CULVER'S JSP 23-37

PLAN REVIEW CENTER REPORT

Planning Review

Revised Preliminary Site Plan with Planned Development 2 Option, Special Land Use Request, and a Street Vacation Request

0

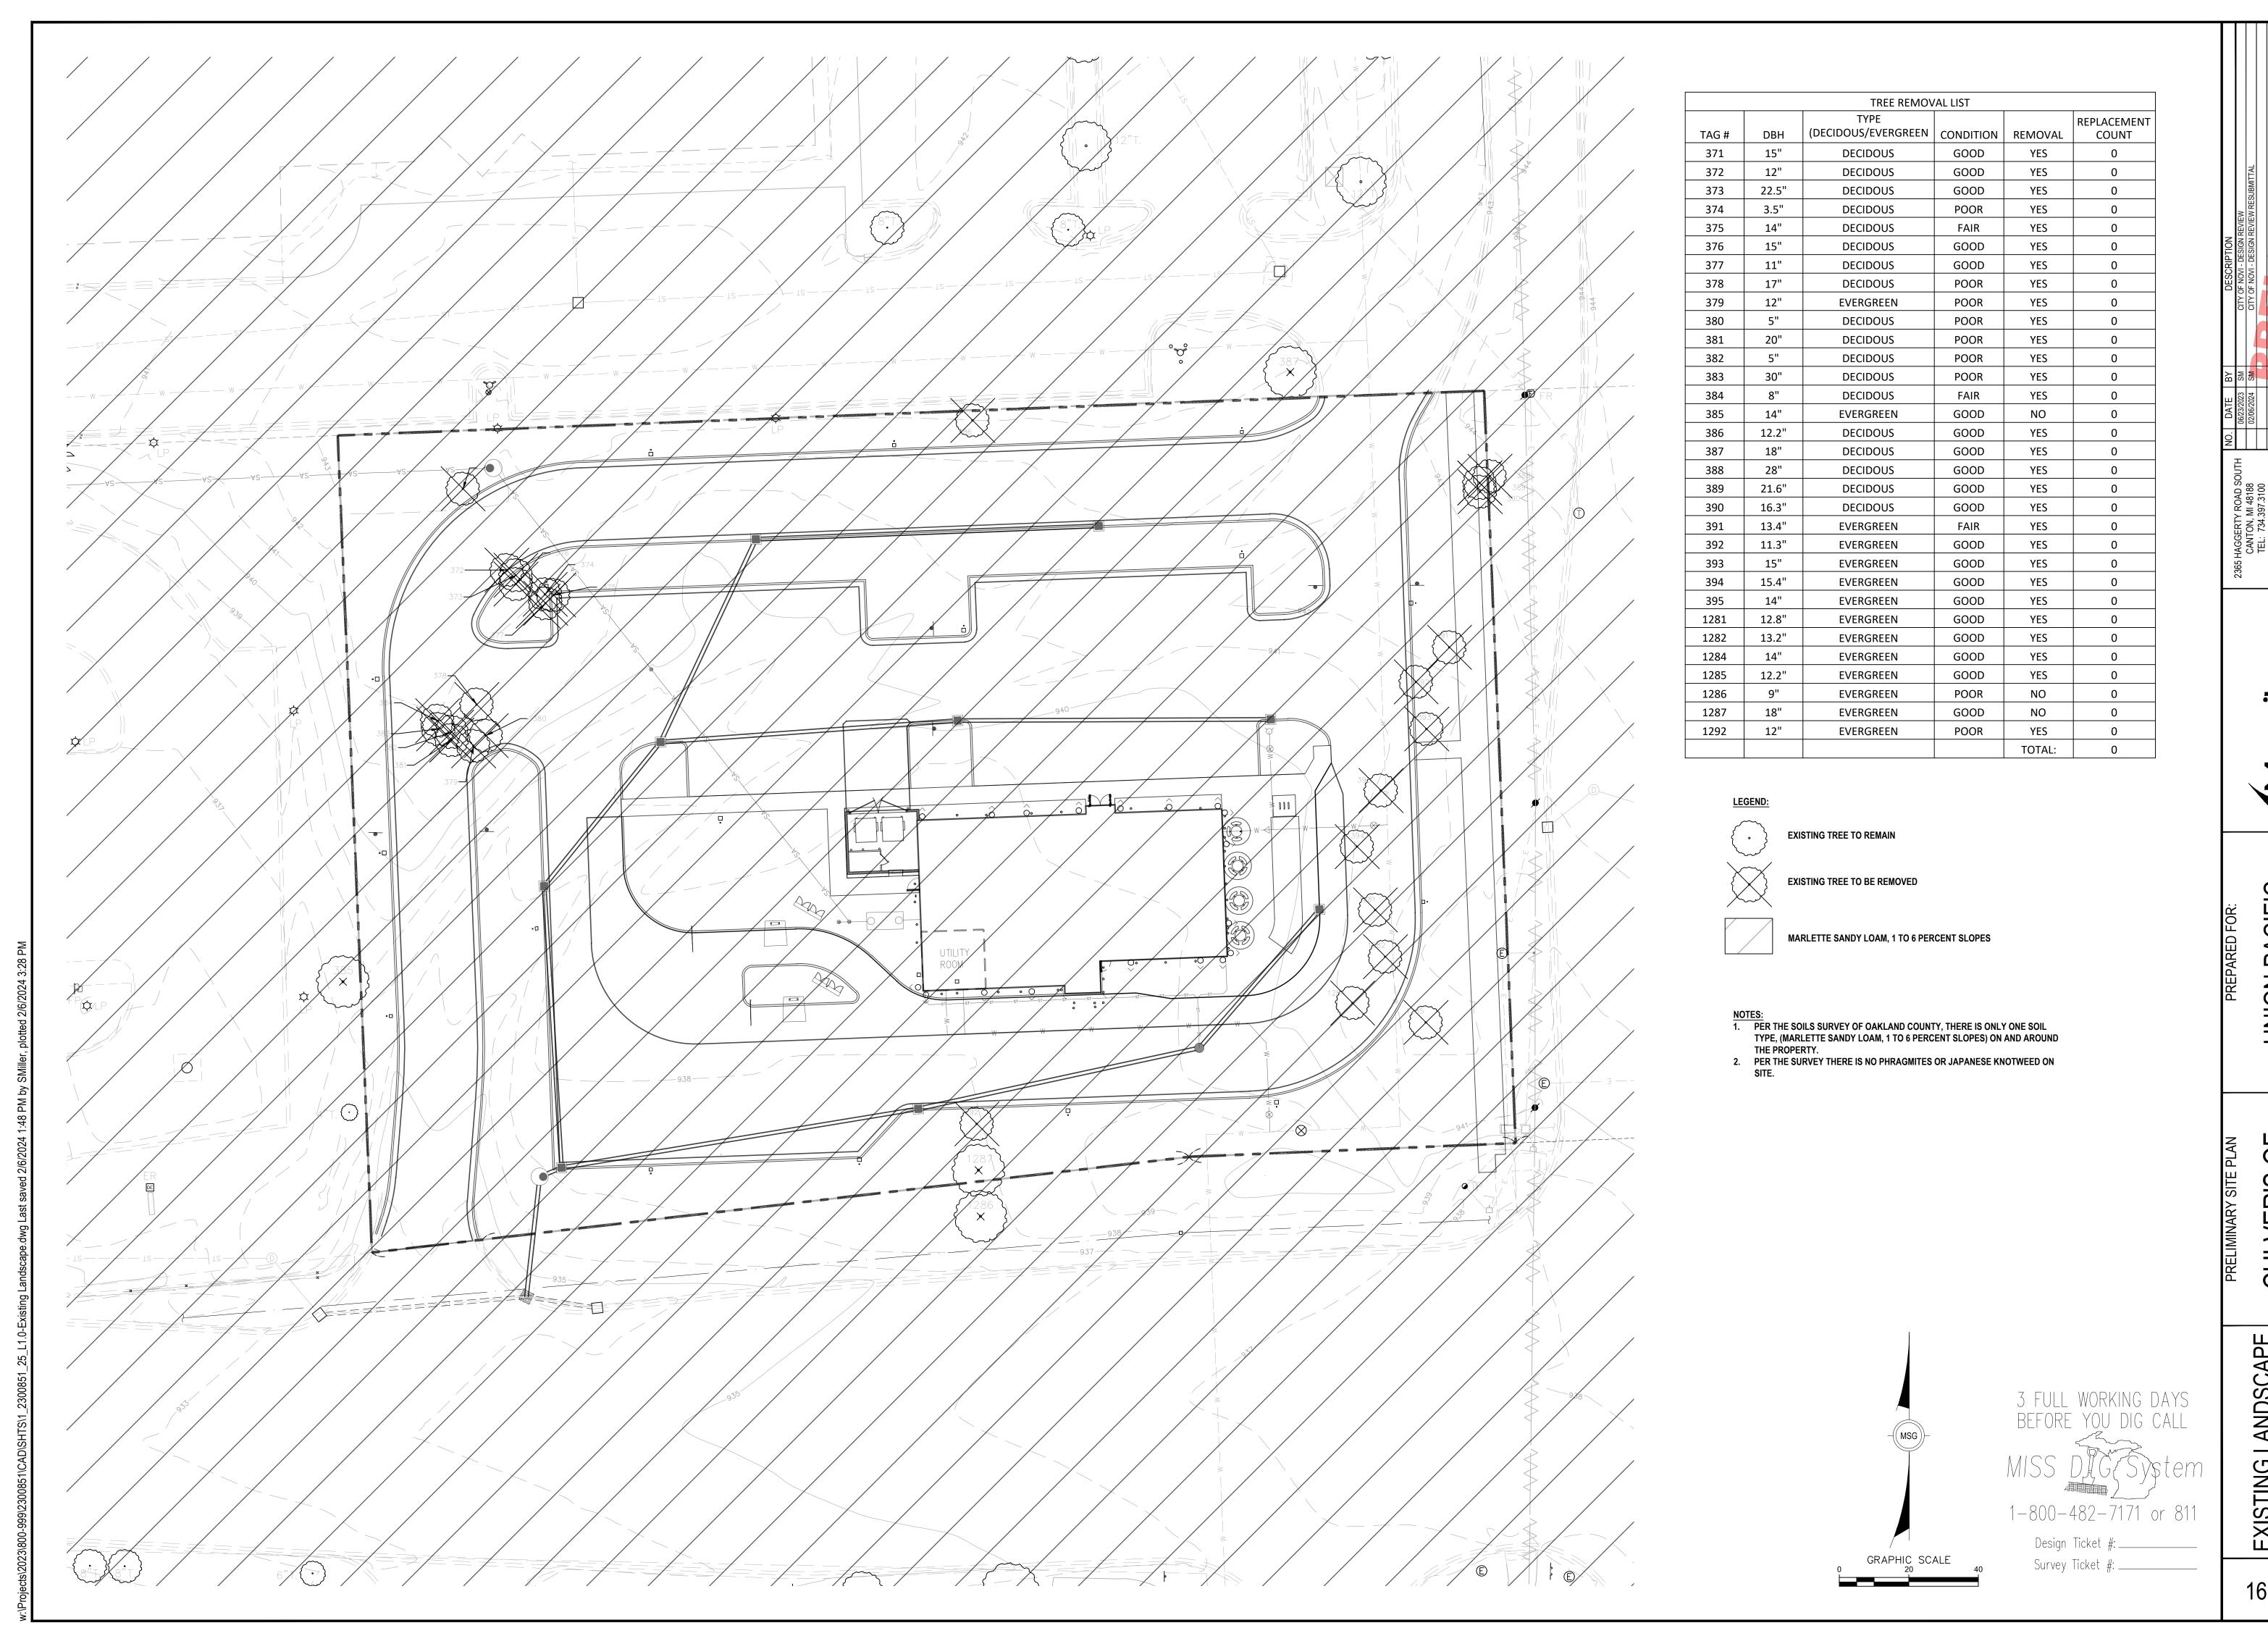
- 37. Remove underground detention details if underground detention is not proposed. (see sheet 12 & 13)
- 38. As part of the Storm Drainage Facility Maintenance Easement Agreement, provide an access easement for maintenance over the pretreatment structure.
